PAUL MEW ASSOCIATES
TRAFFIC CONSULTANTS LTD

TECHNICAL NOTE

Author:	Emily Scott-Holt
Date:	18/08/2016
Project:	PI364: 45 Maresfield Gardens, Camden, London, NW3 5TE Application Number: 2016/2827/P
Subject:	Response to the Council's Delegated Report and Decision Notice

PI364: 45 Maresfield Gardens, London, NW3 5TE
 Figure 2.
 Potential PHO Parking Opportunities

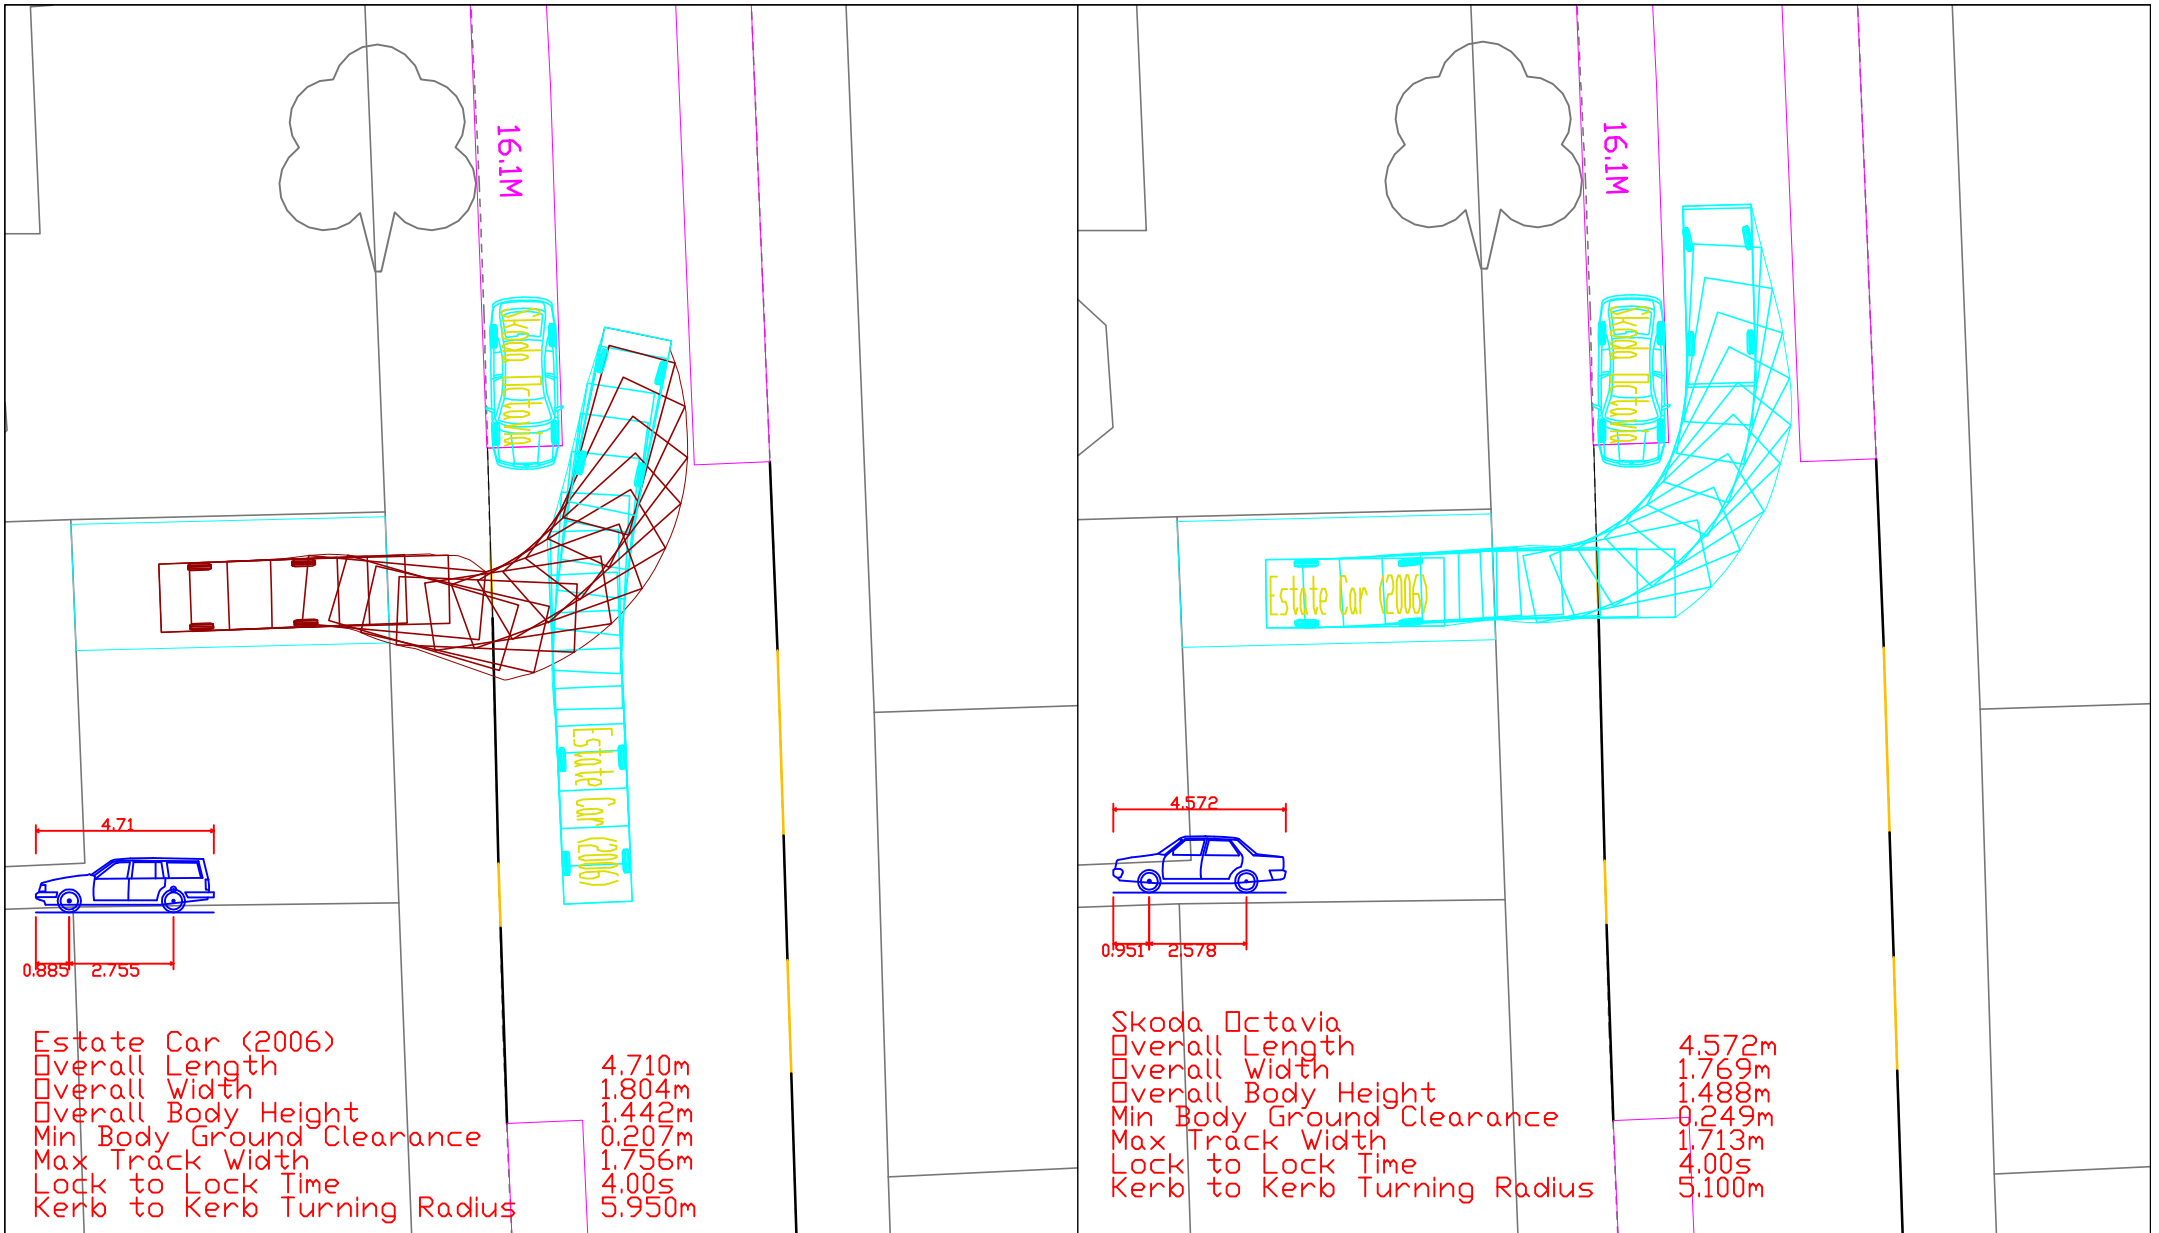
41. It is noted that to the north of the site there is a 13.7, 11.4 and 16.4 metre stretch of SYL which could accommodate at least three PHO parking opportunities comfortably, helping to reduce local parking stress. To the south of the site there is also 12.7 metre stretch of SYL which could be converted to PHO parking opportunities. Refer to Figure 2 which shows the locations of these potential PHO parking opportunities.

40. To help alleviate concerns that the proposal will result in a loss of one on street parking opportunity (however the parking opportunity is measured), the applicant is prepared to fund the conversion of SYL kerb side to PHO parking opportunities within close proximity to the site, to provide a minimum of one replacement on-street parking opportunity for the shortening of the PHO bay adjacent to the site.

Proposed Crossover Layout Options 45 Maresfield Gardens Enforcement Appeal

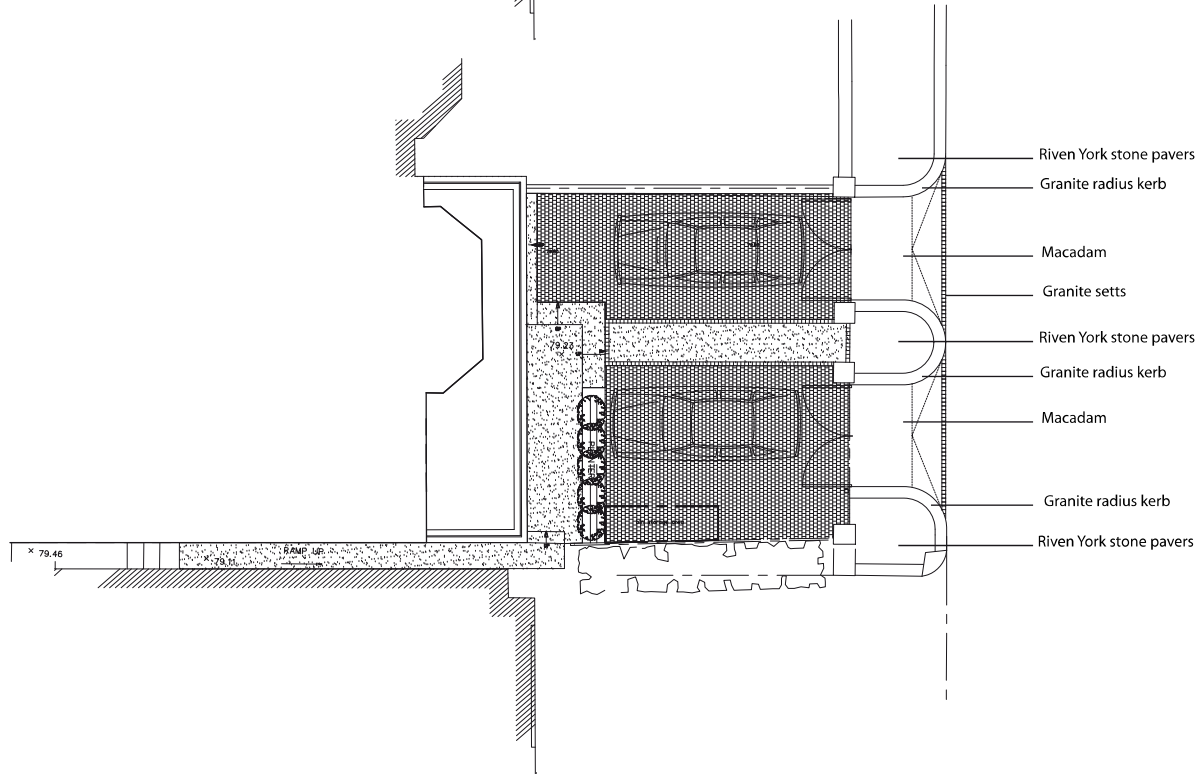
“The forecourt layout creates an excessive distance between points of safety for pedestrians on the footpath.”

30. The proposed crossover has been designed in two ways, as a large single crossover, and as two smaller crossovers with a central refuge for pedestrians, refer to Appendix B. Both crossovers are considered to be appropriate and in keeping with other crossovers on Maresfield Gardens, however the provision of a pedestrian refuge between two smaller crossovers is a safer design for pedestrians, by providing shelter from vehicles using the crossover.

PI364: 45 Maresfield Gardens, London, NW3 5TE
 Appendix C.
 Swept Path Analysis: Estate Car

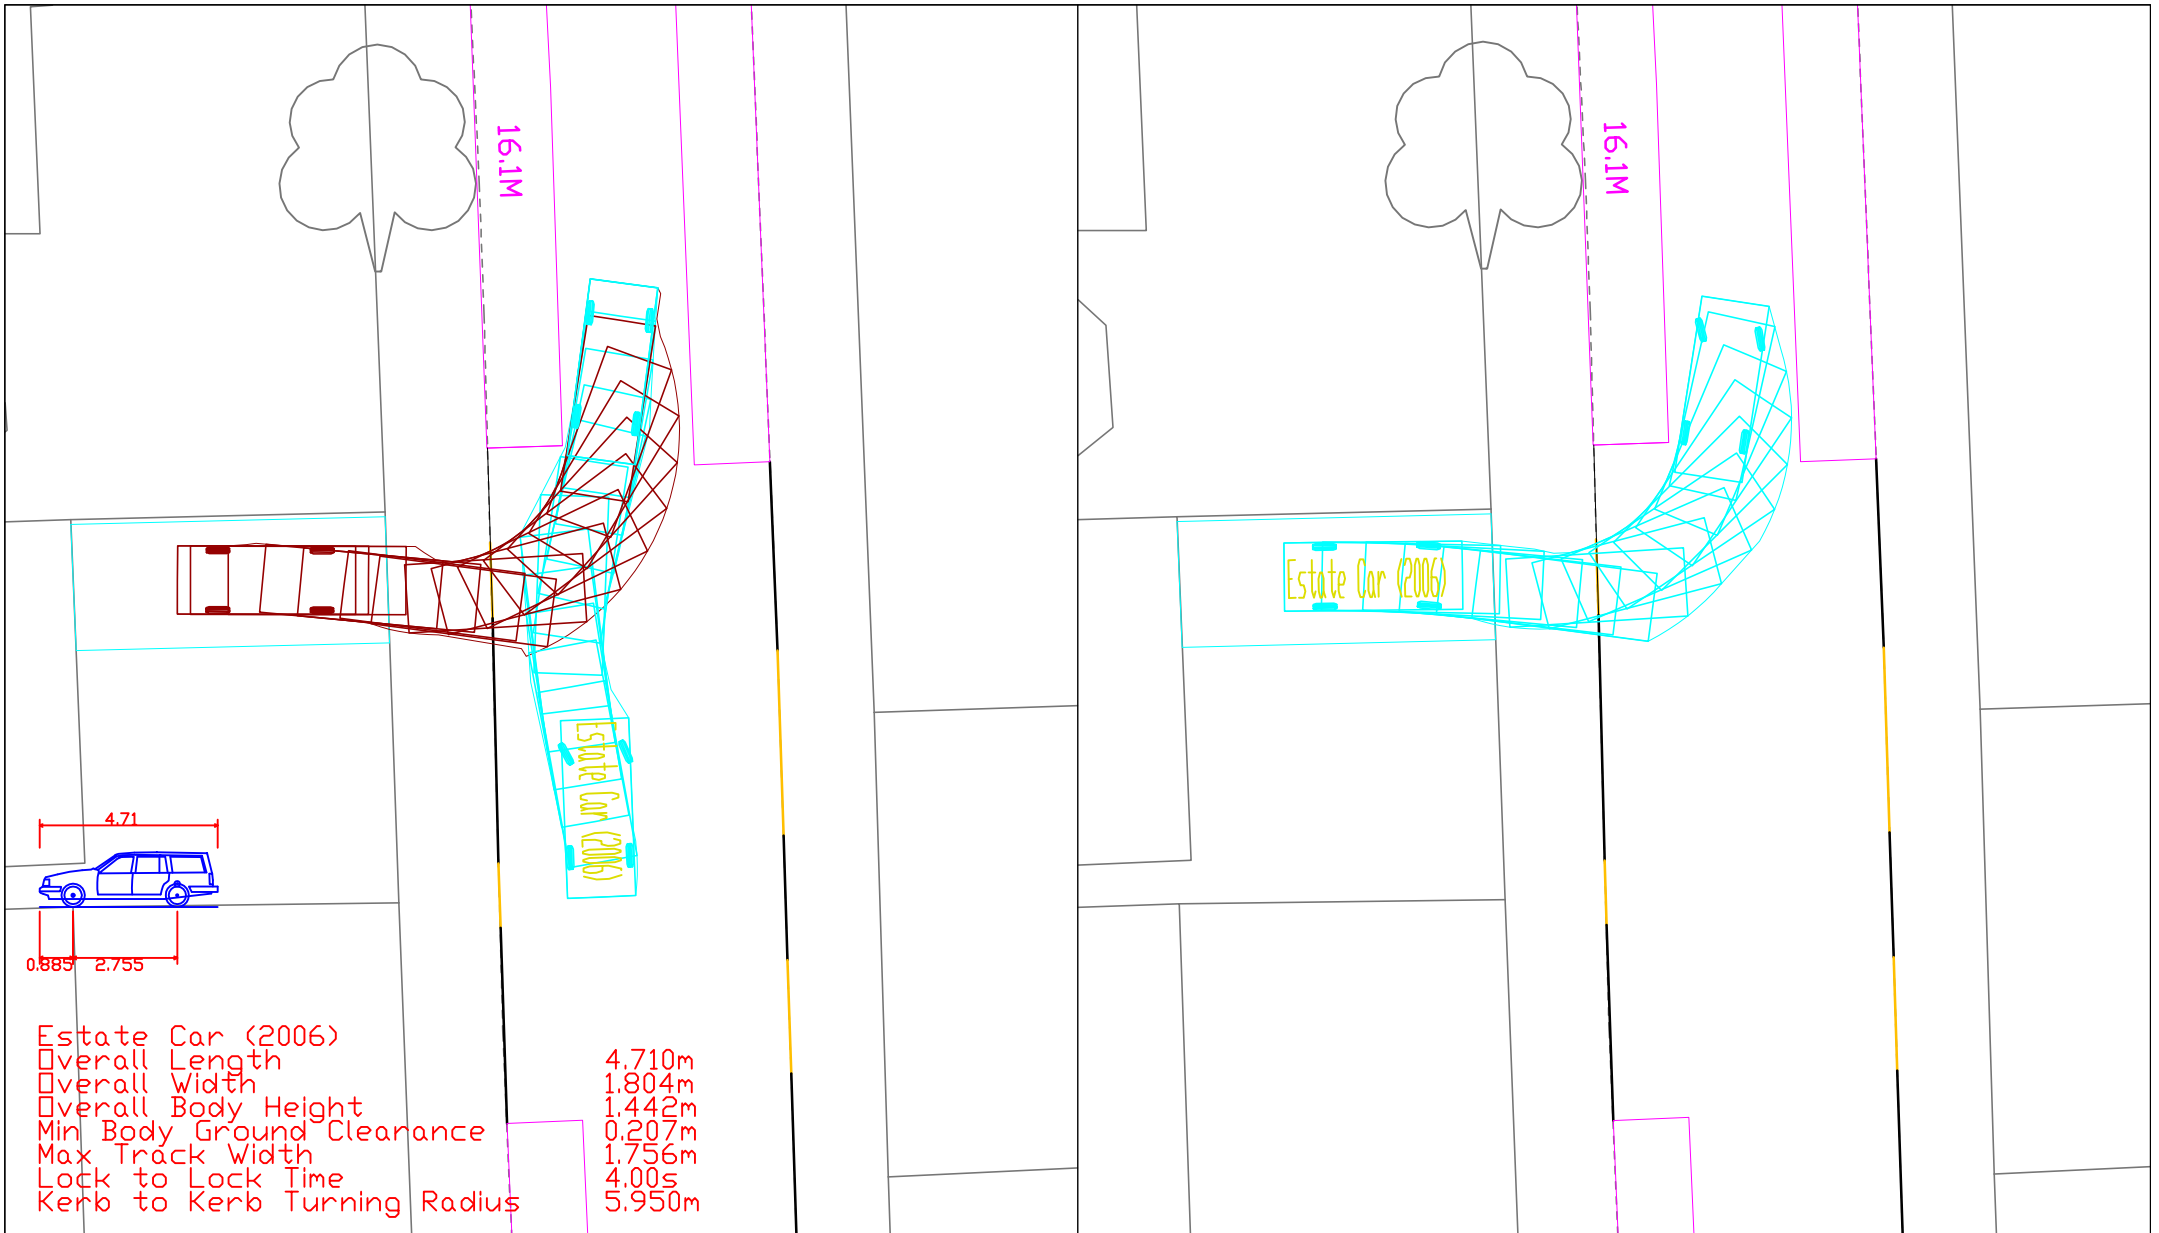
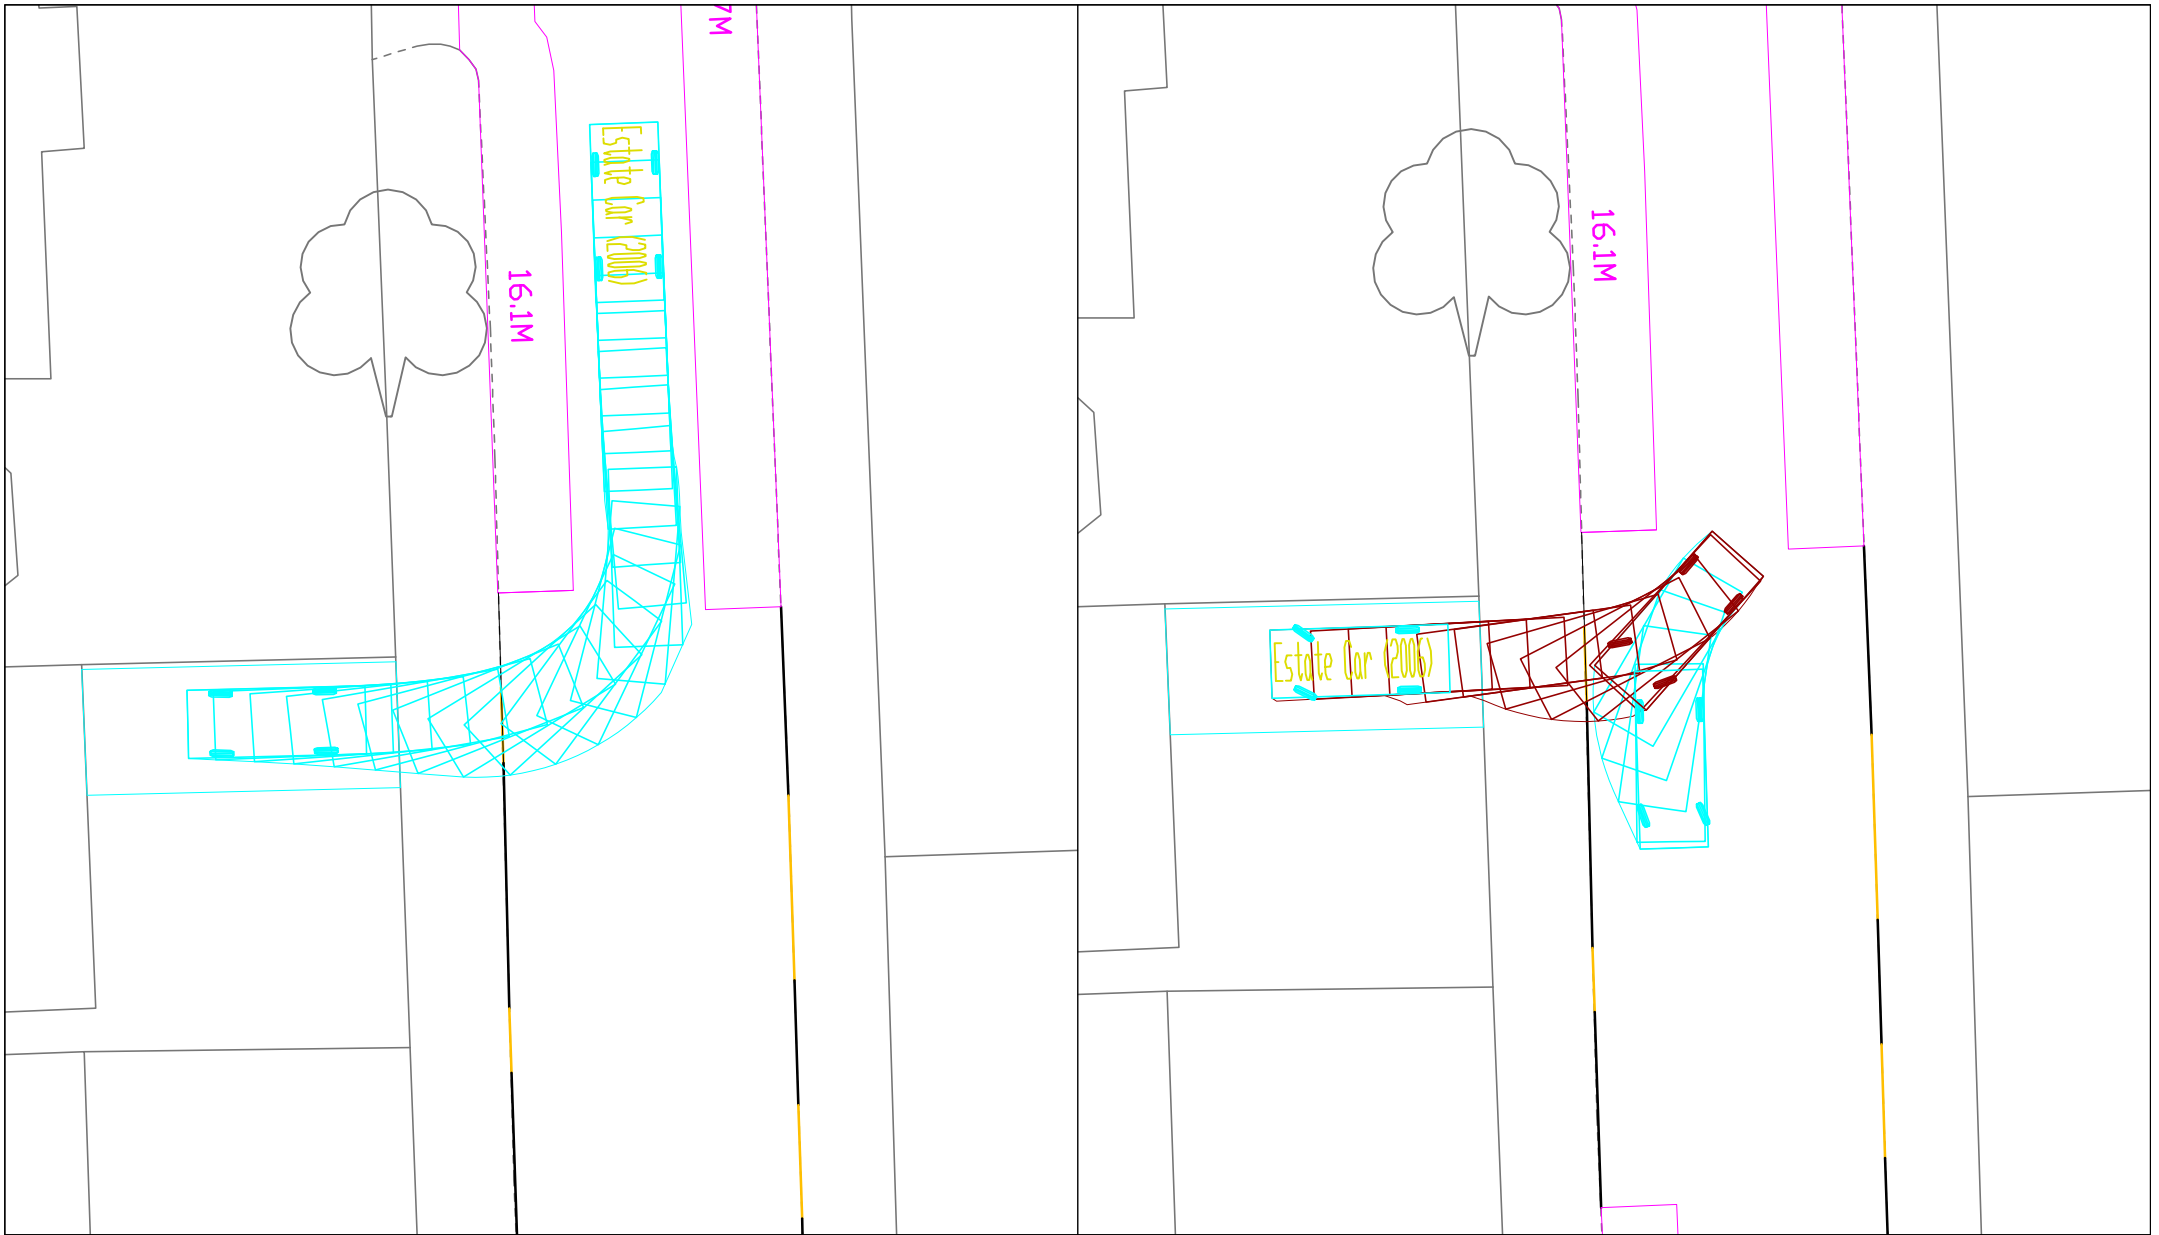
“Vehicles using the parking opportunity are unable to enter from the north, and exit left without crossing to the other side of the road.”

“The swept path analysis has not taken into consideration the location of on-street parking bays.”

36. A large estate car has been used in the swept path analysis to demonstrate that the manoeuvres are possible with an above average length of vehicle.
